Section 96(1A) Modification Application Environmental Assessment

For:
Faculty of Arts and Social Sciences (FASS),
University of Sydney

SSD 7081

August 2017

DA1070

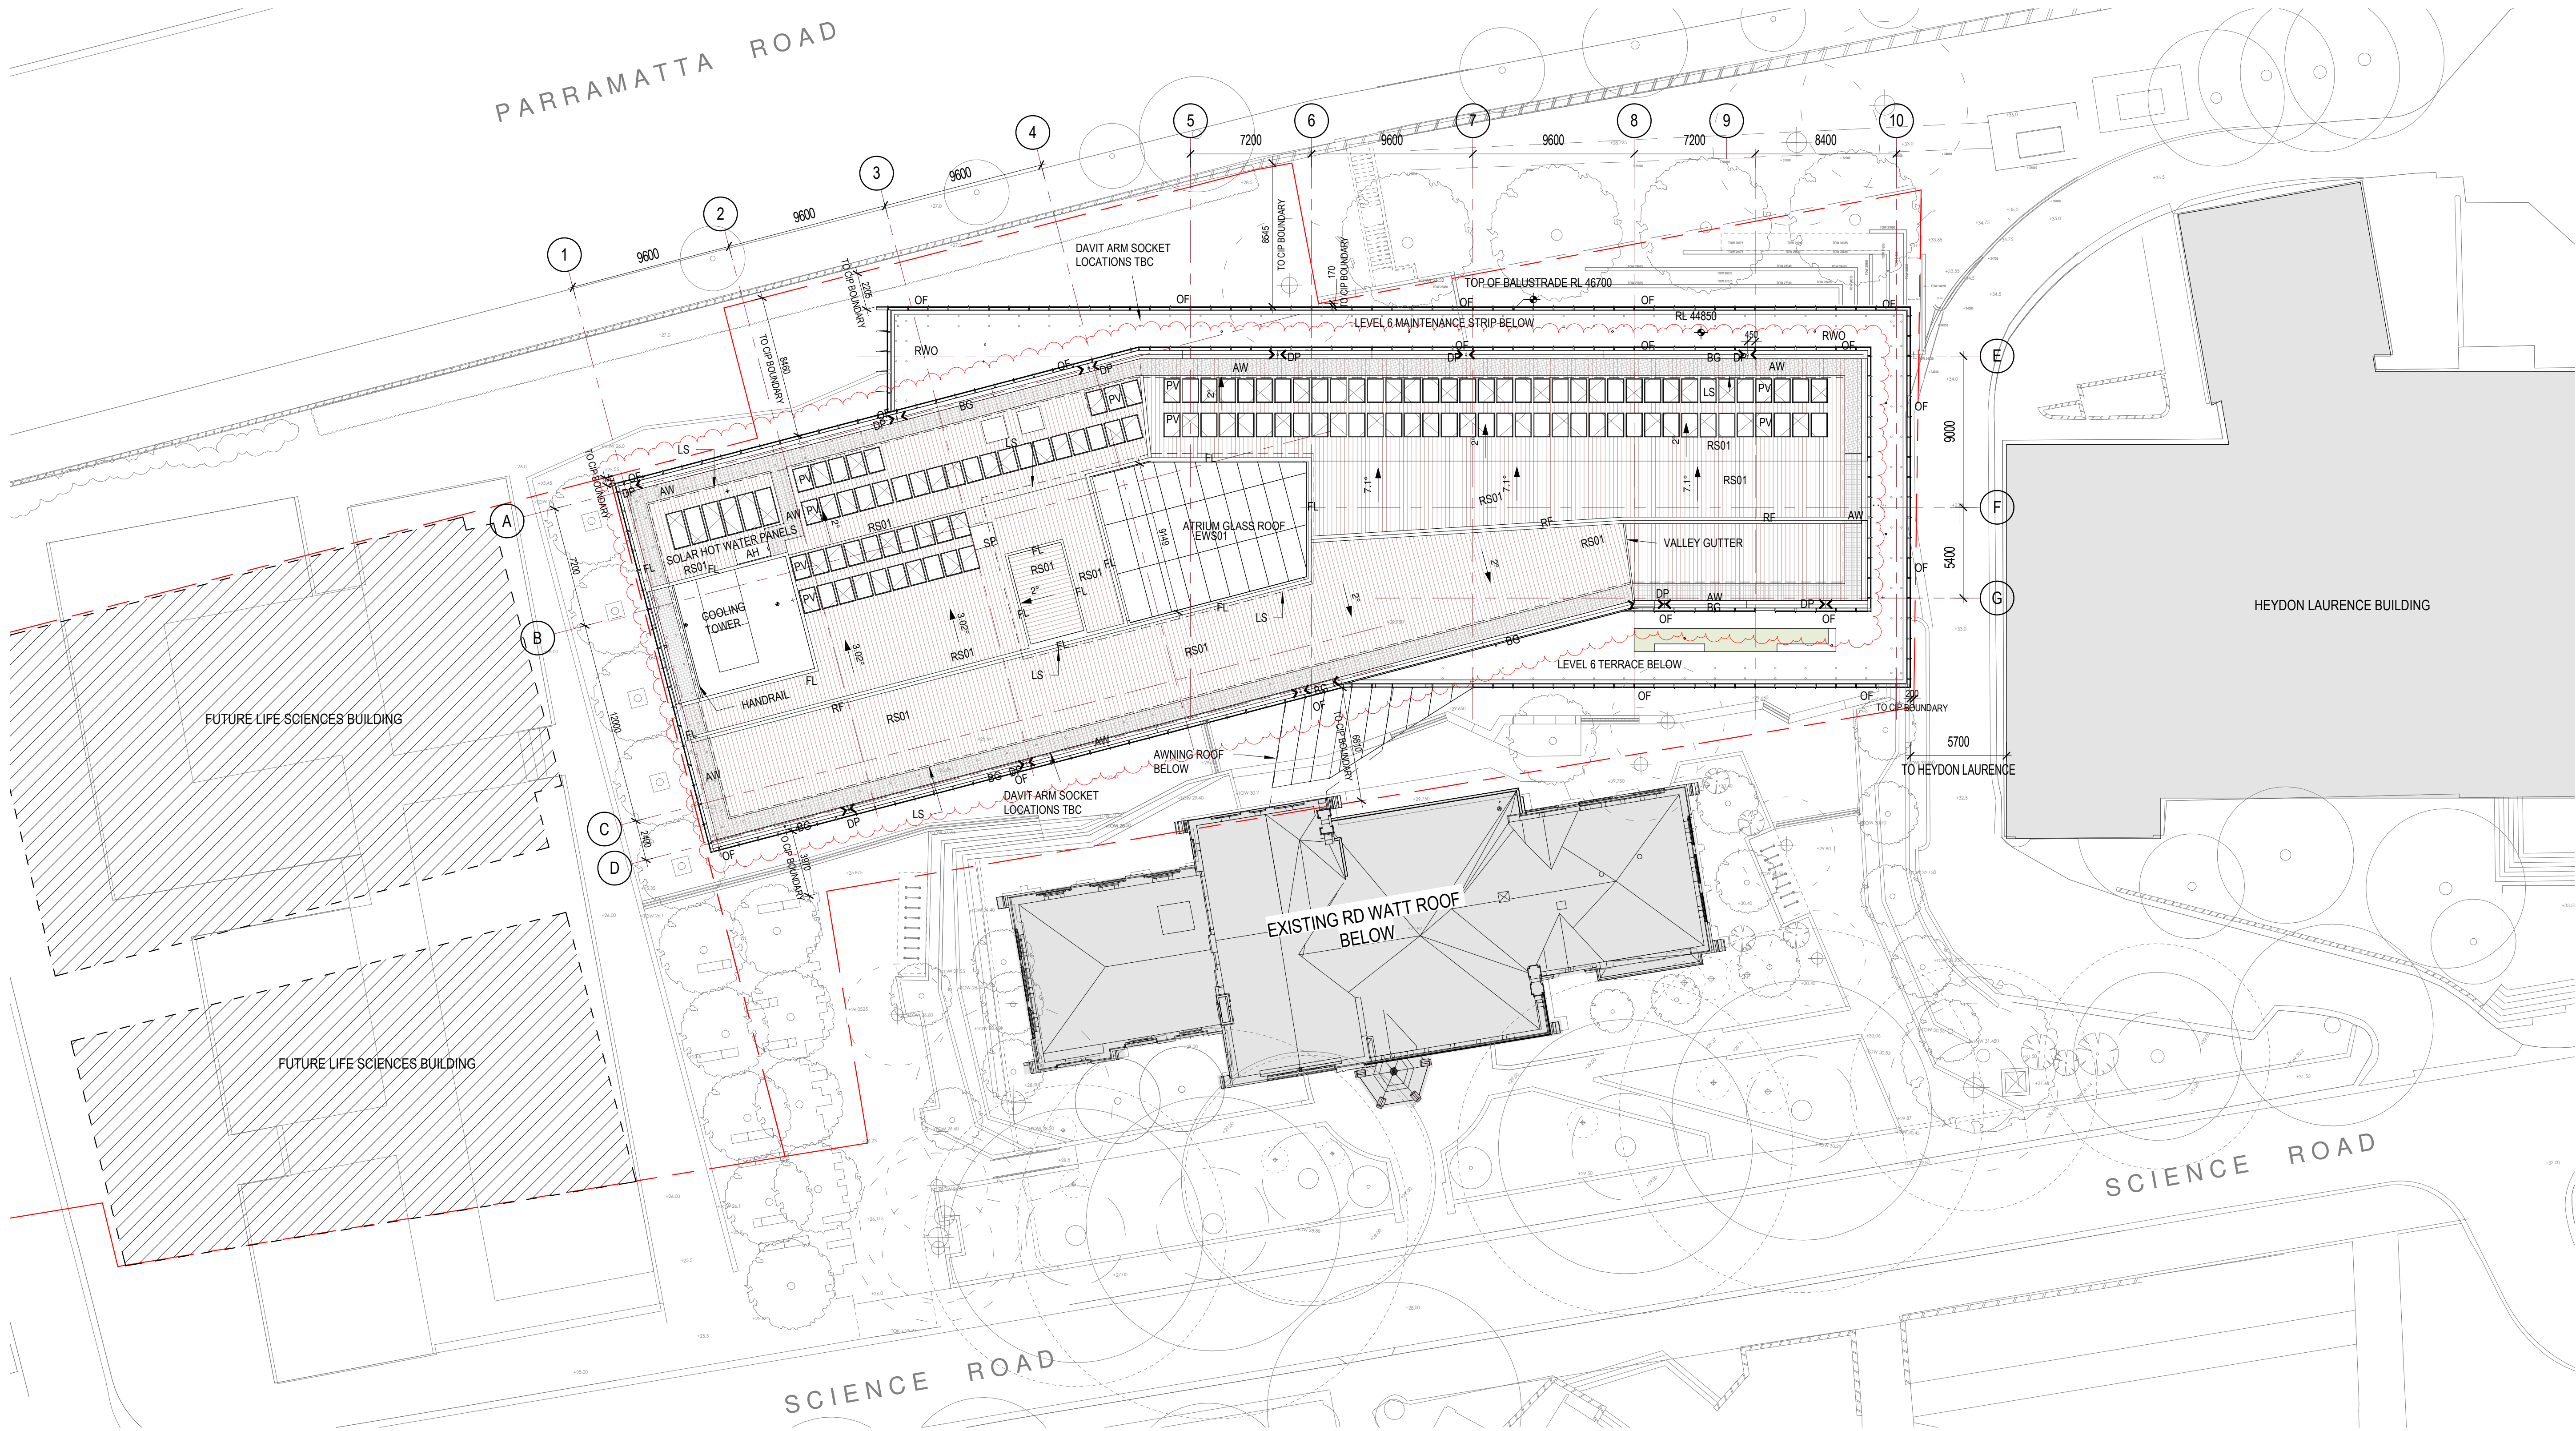
COLORBOND SURFMIST

PROPOSED EXTERNAL FINISHES

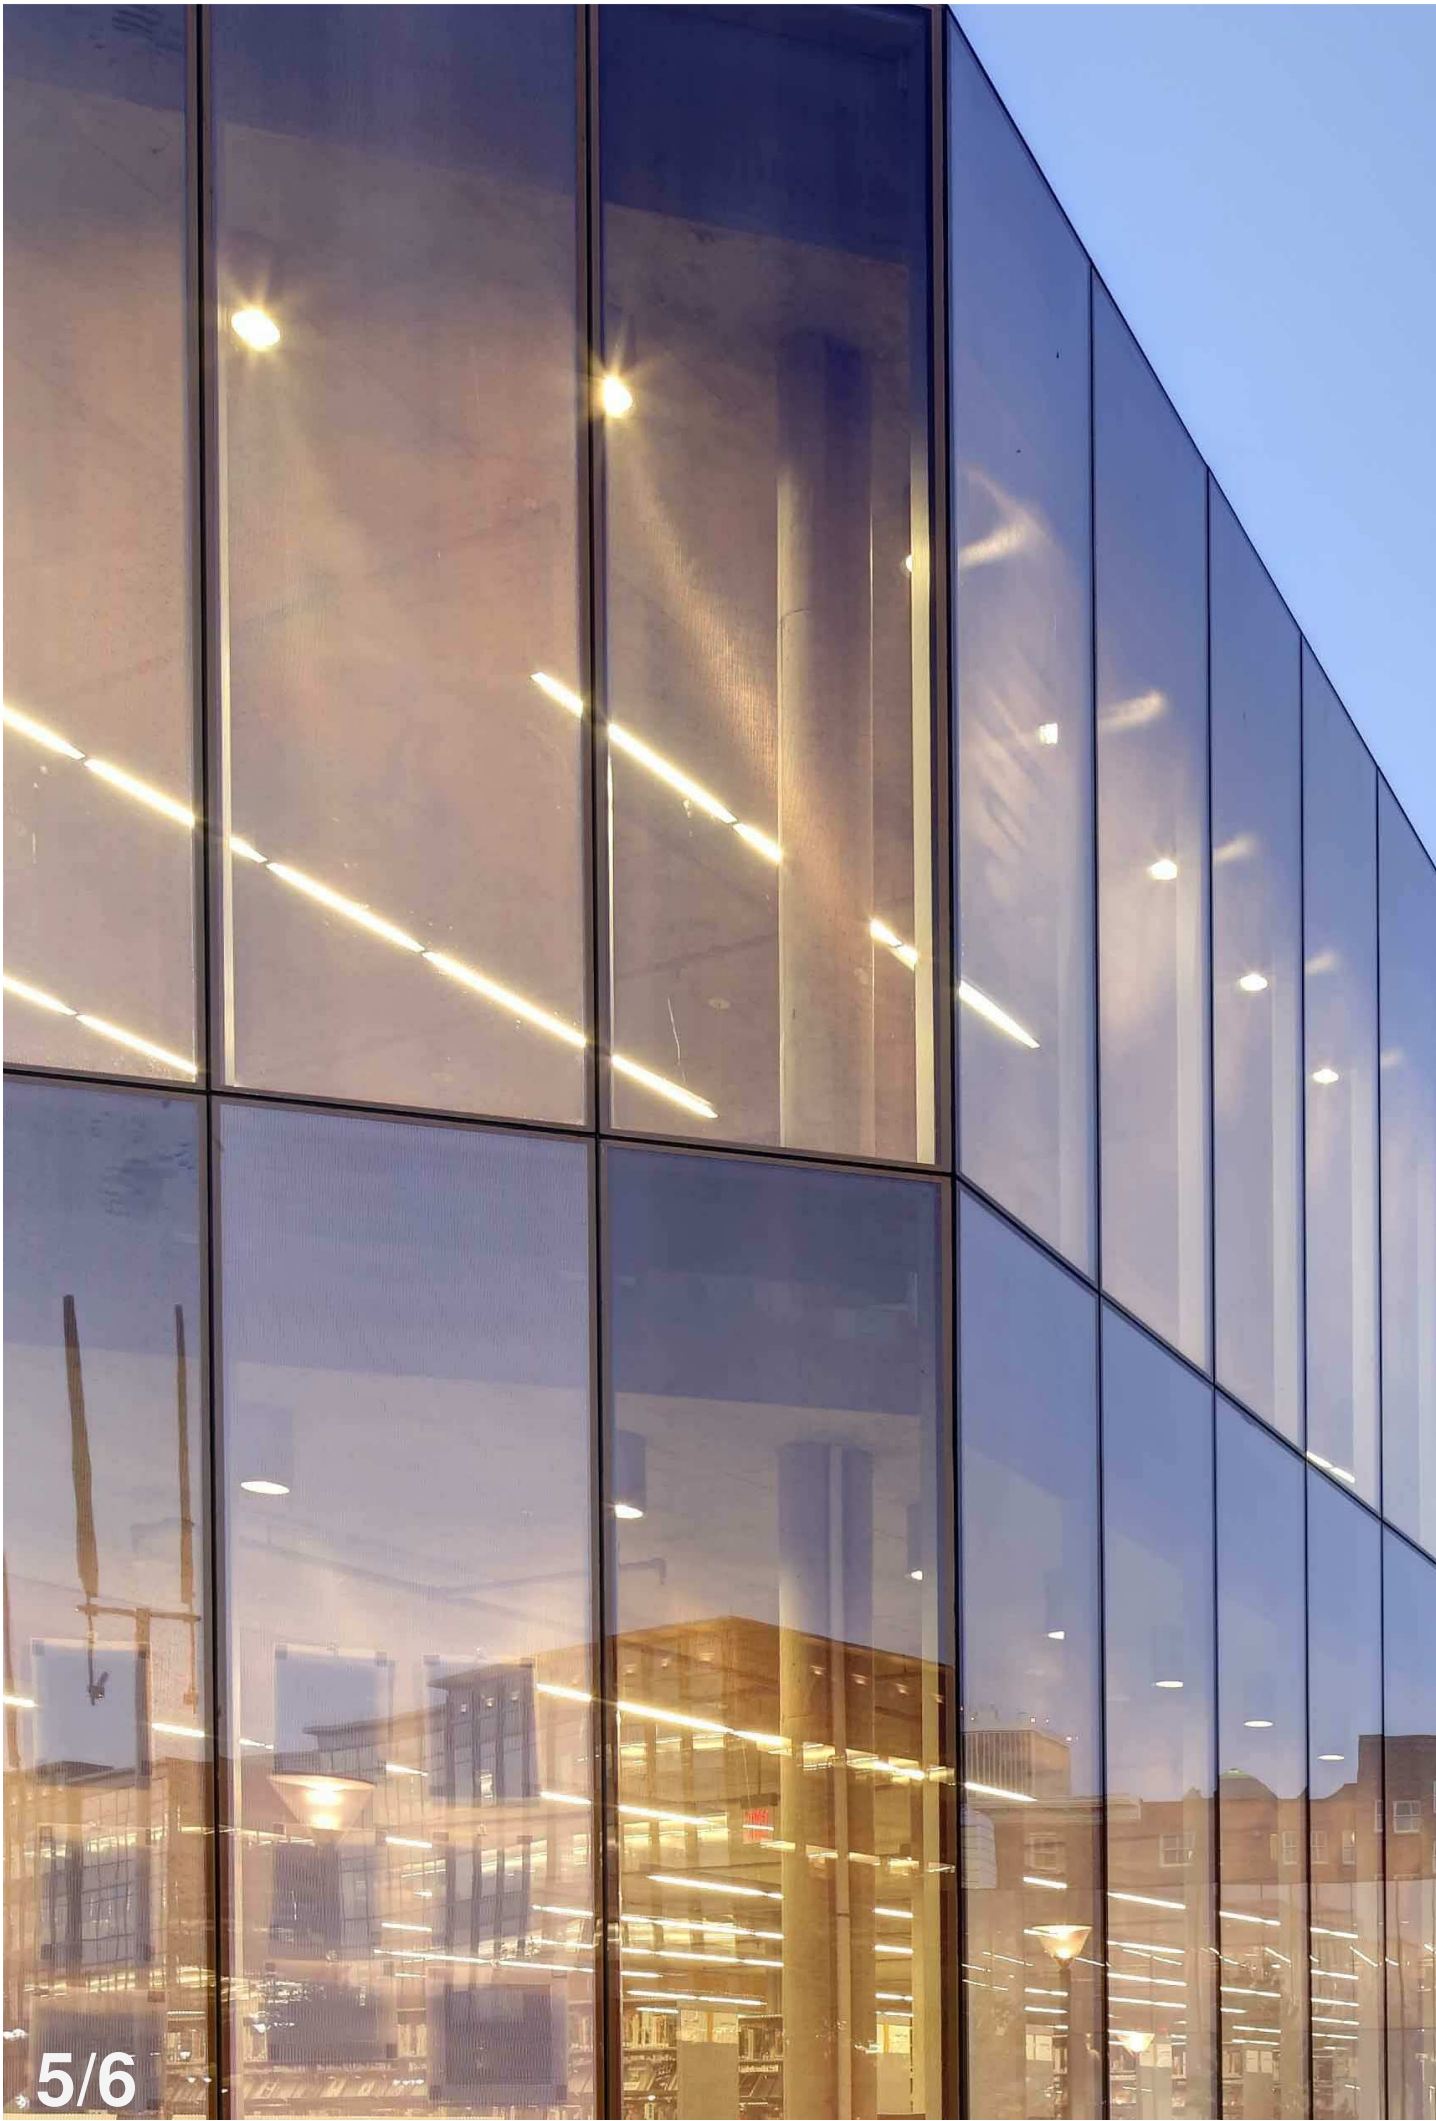
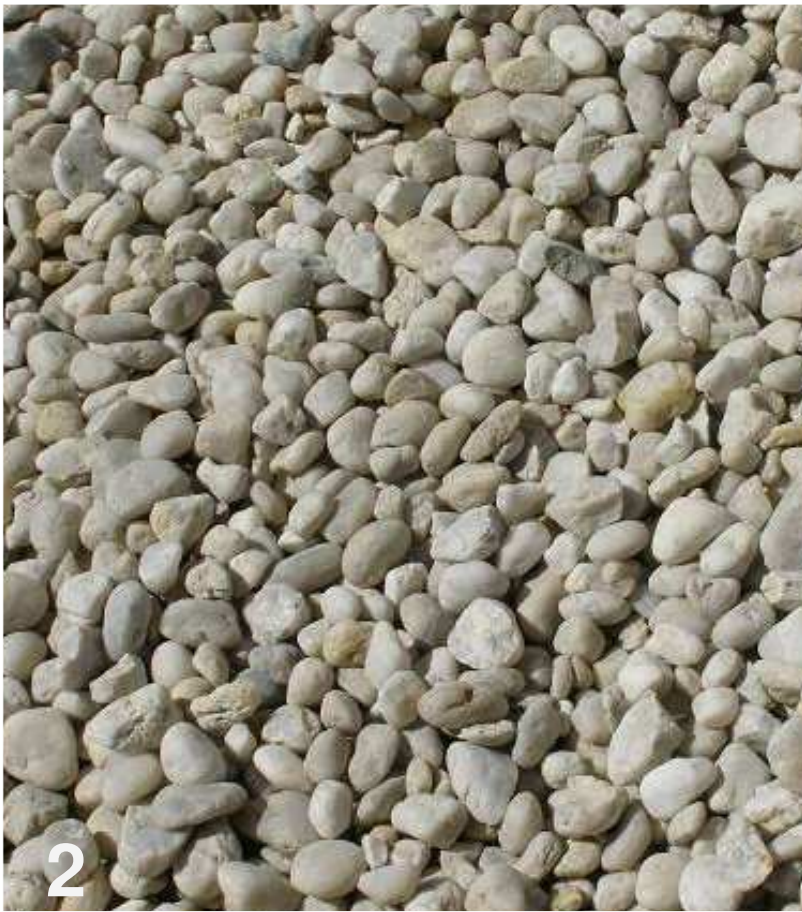
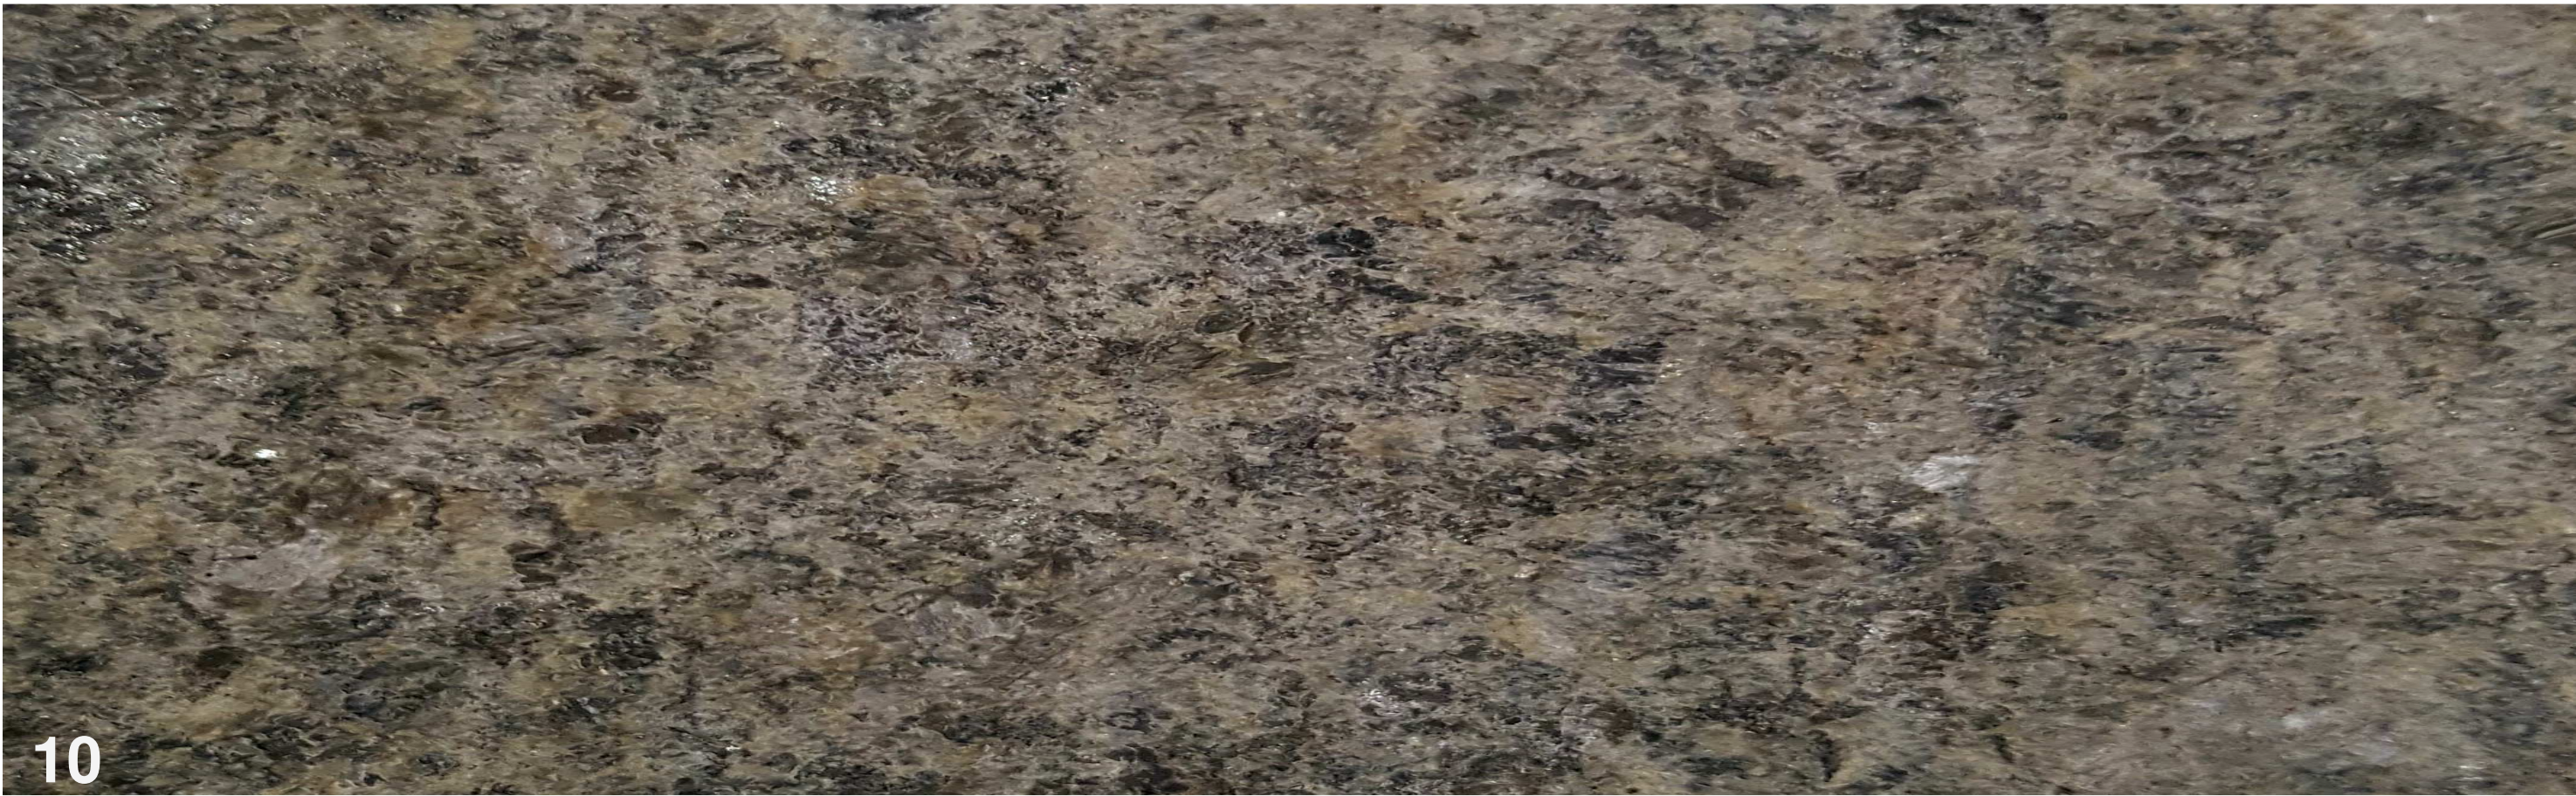
- 1 ROOF SHEETING - COLORBOND SURFMIST
- 2 PEBBLES - COWRA WHITE
- 3 ANODISED ALUMINIUM MULLIONS - WARM METALLIC COLOUR
- 4 ANODISED ALUMINIUM MULLIONS - NATURAL
- 5 HIGH PERFORMANCE DOUBLE-GLAZED, CURTAIN WALL SYSTEM WITH INTER-LAYER
- 6 CURTAIN WALL PANEL TO MATCH MESH SCREEN IN A 2 STAGE LOUVRE SYSTEM
- 7 CLEAR LOW IRON DOUBLE GLAZED UNIT
- 8 CLEAR LOW IRON HIGH PERFORMANCE GLASS
- 9 CLEAR LOW IRON ENGINEERED GLASS FACADE
- 10 GRANITE - STONE CLADDING
- 11 PERFORATED ALUMINIUM SCREEN TO LOUVRE, NATURAL ANODISED
